D.O. No. RW/34032/1/86-NH-Stds.

Subject : Passenger-Oriented Wayside Amenities.

S I T E P L A N WF/01
WAYSIDE FACILITIES ON NATIONAL HIGHWAYS (PREPARED BY MINISTRY OF SURFACE TRANSPORT (ROADS WING) IN CO-OPERATION WITH CONSULTING ENGINEERING SERVICES (INDIA) PVT. LTD NEW DELHI
 SCALE: 1 cm = 10.00 m DATE: NOVEMBER 1987

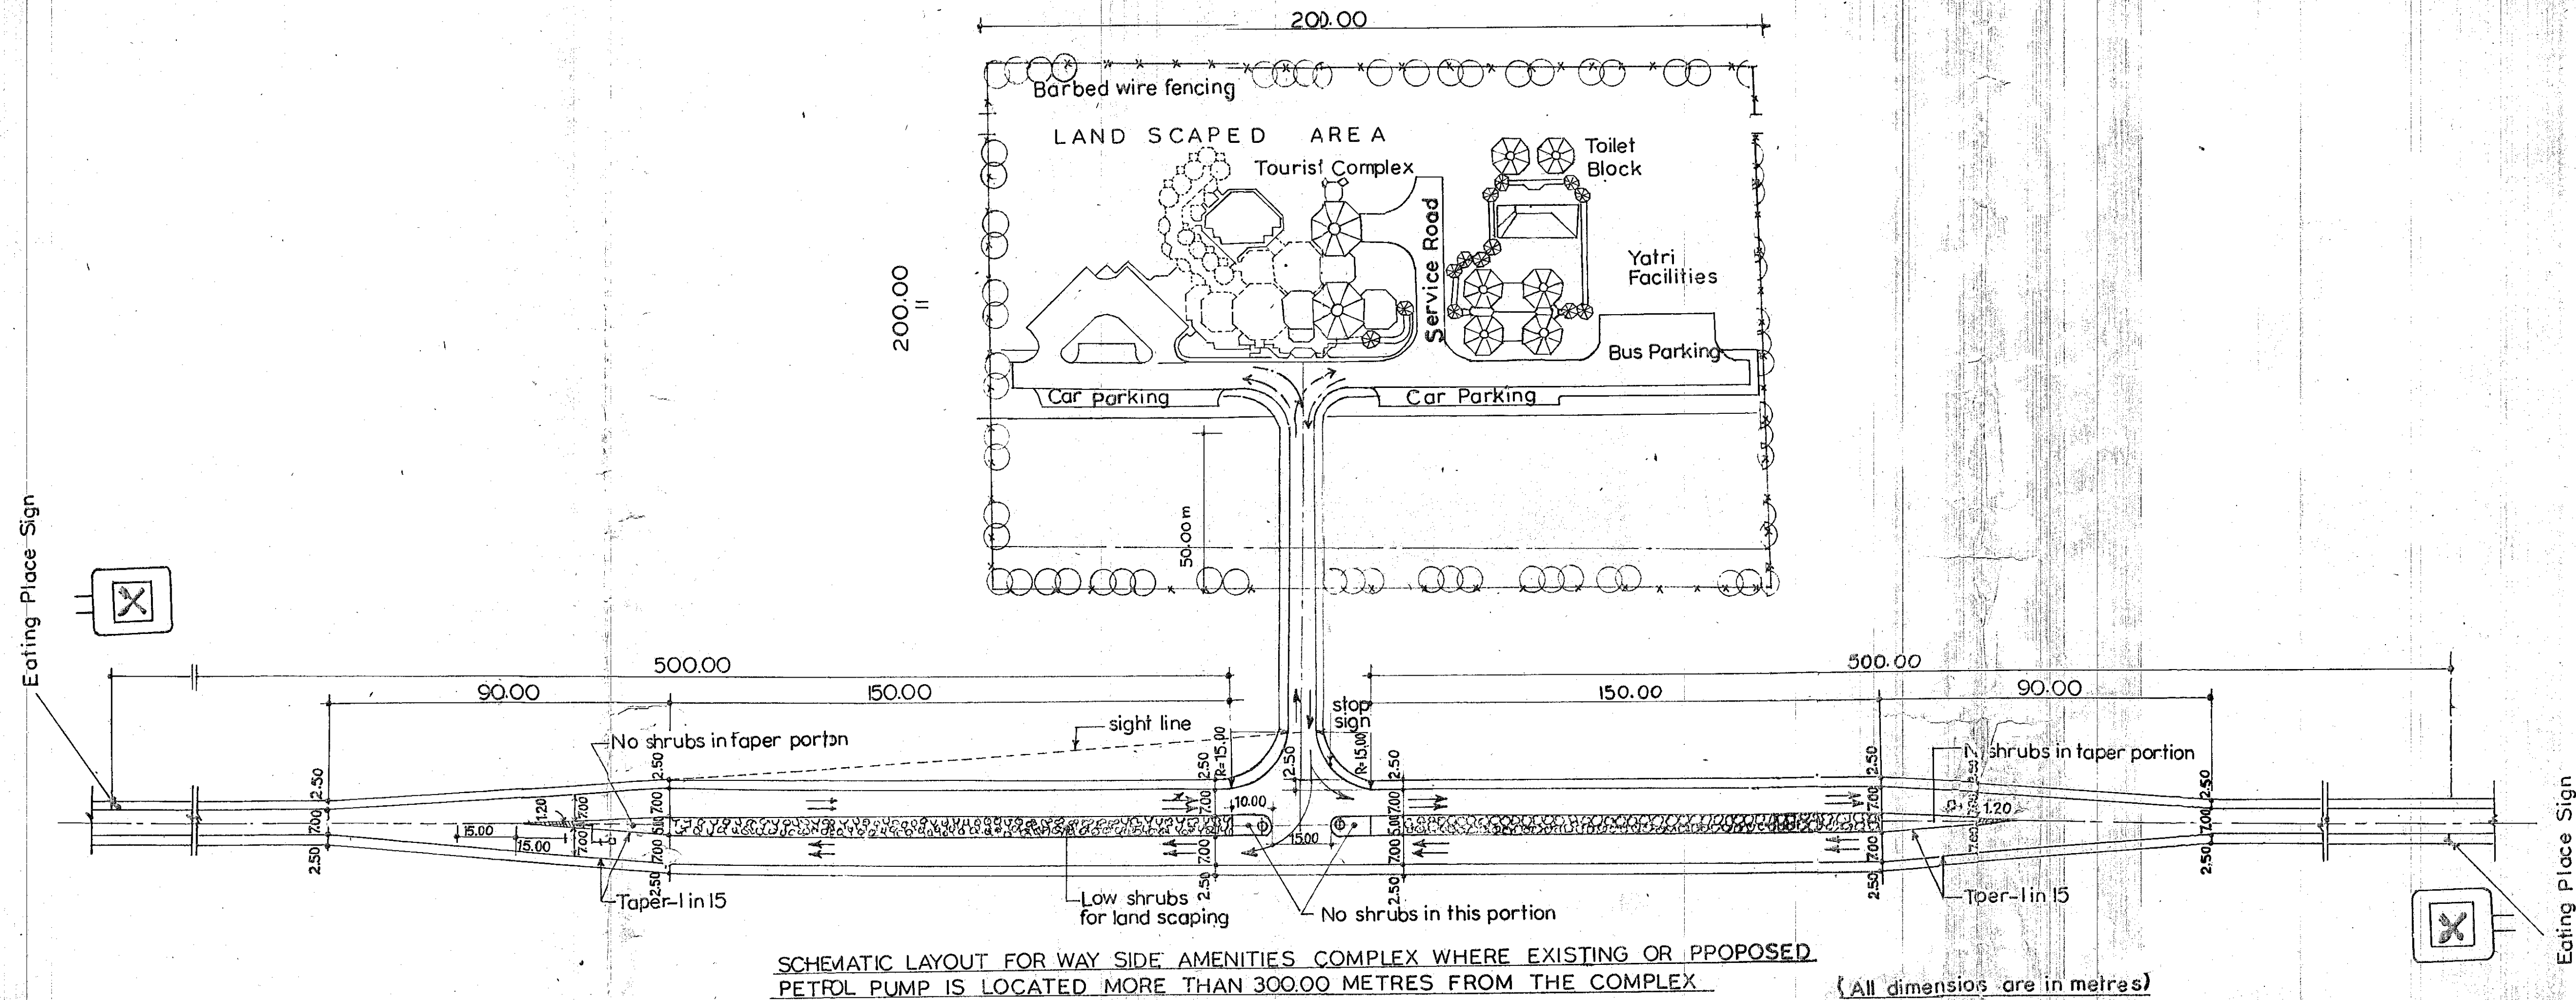
Kindly refer to this Ministry's DO letter of even number dated the 30th October, 1986 forwarding two illustrative drawings for passenger-oriented wayside amenities. We have since reviewed these drawings and made a few modifications, as will be seen from the three modified typical drawings enclosed. Revised drawings have been prepared by us with active cooperation of M/s Consulting Engineering Services (India) Pvt. Ltd., New Delhi, and are recommended by way of general guidance for future.

2. Drawings WF/01 and WF/02 pertain to needed improvements on the National Highway. Depending on whether or not a petrol pump is situated closeby, either of the two layouts could be adopted to ensure smooth flow of traffic in and out of the complex.
